Mecklenburg County
Health Department

Re: New Subdivision/Moore's Chapel Road, lot 10
File: 3304B
Parcel: 053-174-07

Receipt of the plans and specifications for a conventional system of sewage treatment and disposal for the above property is hereby acknowledged. Upon receipt of the information, a review was made of the material on file and a site evaluation was conducted. The plan was then reviewed in conjunction with provisions of 15A NCAC 18A .1900, "Laws and Rules for Sewage Treatment and Disposal Systems." Our comments are listed below (see enclosed soil report):

MECKLENBURG COUNTY HEALTH DEPARTMENT
SITE EVALUATION REPORT
SERIAL NUMBER 028653

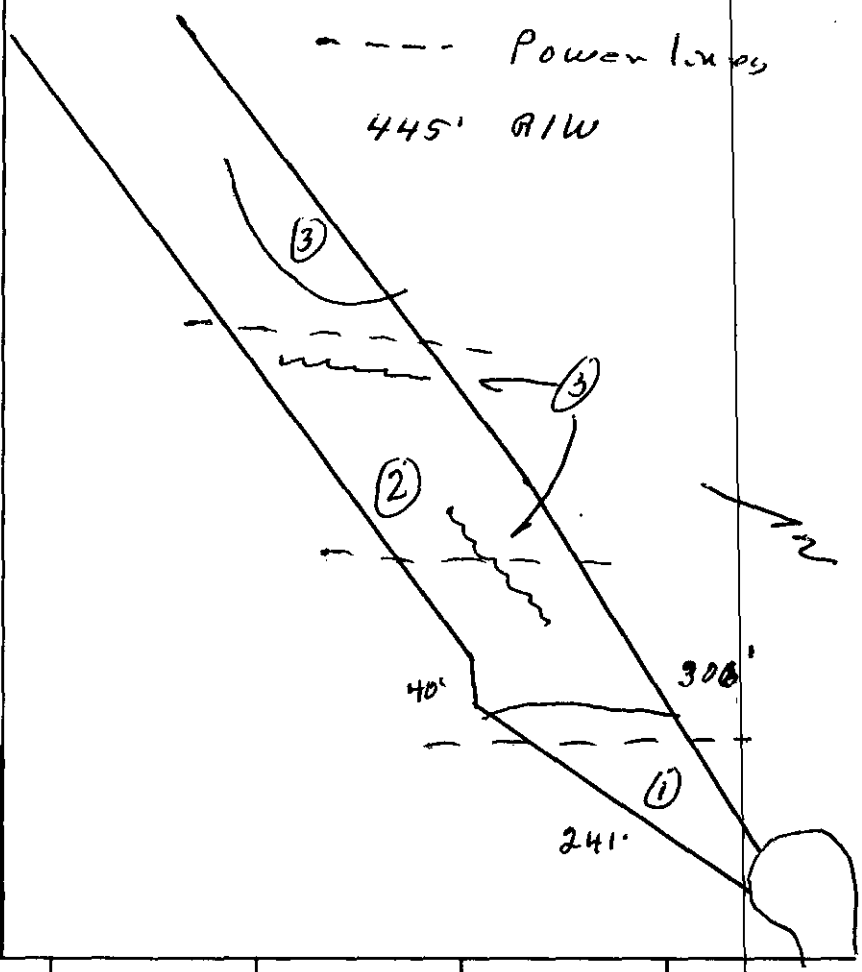
Comments: 100% Repair, .3 gal/ft²/day LTAR, system should be pumped into Parke W/E area

FACTORS	AREA 1	AREA 2	AREA 3	AREA 4	AREA 5	AREA 6
Topography	(S) PS U 2-10%	(S) PS U 2-10%	S PS (U) complex slopes	S PS U	S PS U	S PS U
Texture	S (PS) U slightly Exp. clay	S (PS) U slightly Exp. clay	S PS U —	S PS U	S PS U	S PS U
Structure	S (PS) U Blocky	S (PS) U Blocky	S PS U —	S PS U	S PS U	S PS U
Drainage	S (PS) U 736" To soil wetness	S (PS) U 736" To soil wetness	S PS U —	S PS U	S PS U	S PS U
Depth	S (PS) U 40-43"	S PS (U) 21-31"	S PS U —	S PS U	S PS U	S PS U
Restrictive Horizons	S (PS) U 745"	S (PS) U 736"	S PS U —	S PS U	S PS U	S PS U
Available Space	S PS (U) Restricted	S PS (U) Restricted	S PS U —	S PS U	S PS U	S PS U
Other (specify)	S PS U	S PS U	S PS U	S PS U	S PS U	S PS U
Soil Group/Series	IIe Cecil-Lilo	IIe Pacolet-Lilo	Complex Slopes			
Area Classification	S PS (U)	S PS (U)	S PS (U)	S PS U	S PS U	S PS U

PROPOSED PLOT PLAN

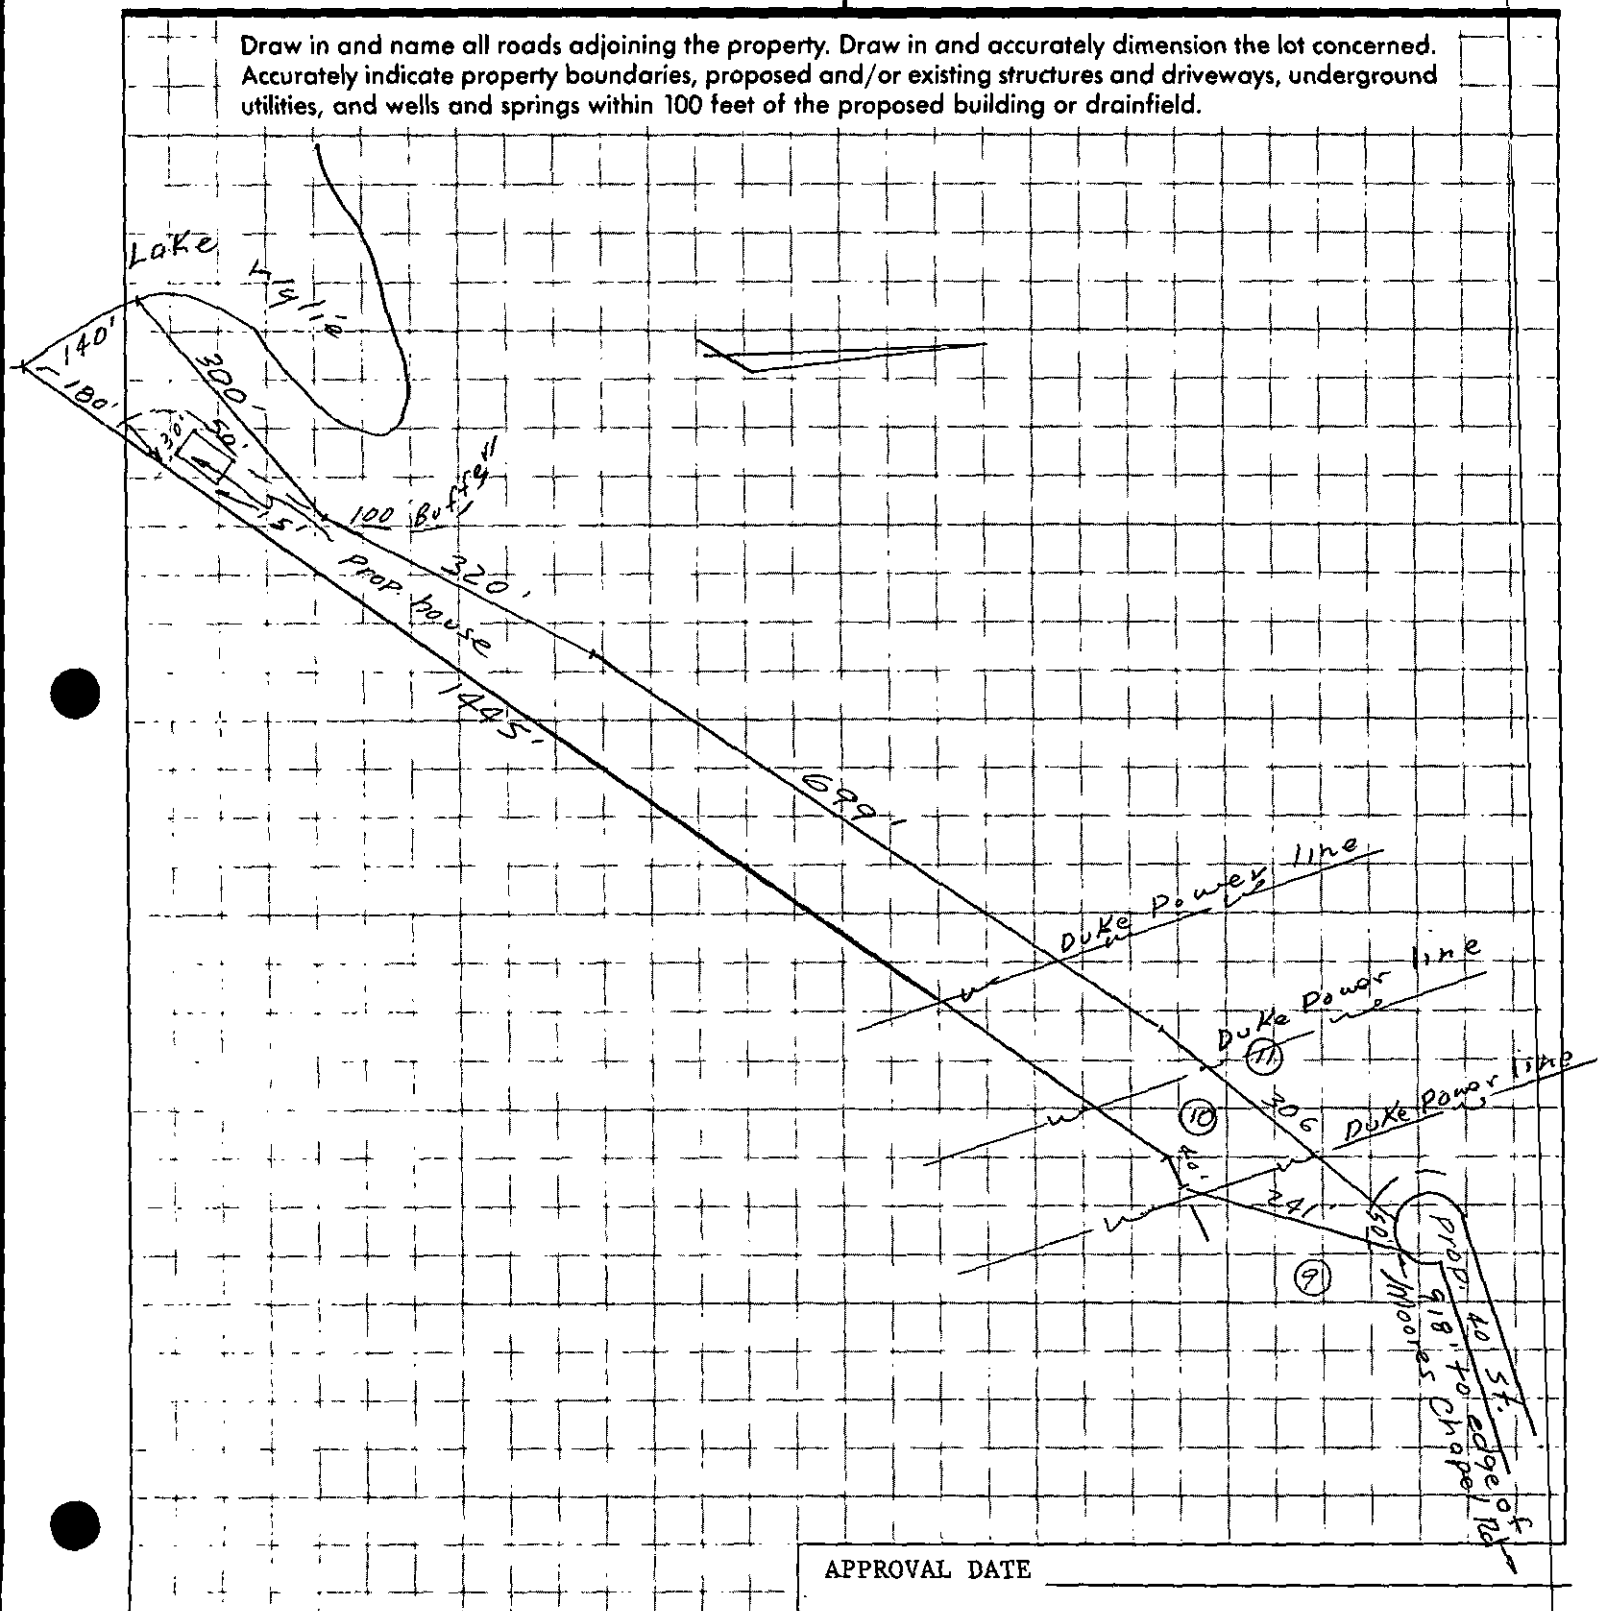
1- The available area on this site is classified as **UNSUITABLE** according to the following rules:
   (a) .1940 Topography and Landscape Position
   (b) .1945 Available Space

For these reasons, the plans as submitted are disapproved.

Possible ways to develop this site includes submittal of a plan for a Prefabricated, Permeable Block Panel System (PPBPS). These plans would also need to include appropriate surface water diversions. Enclosed is a copy of Rule .1956 Modifications to Septic Tank System pertaining to PPBP Systems.
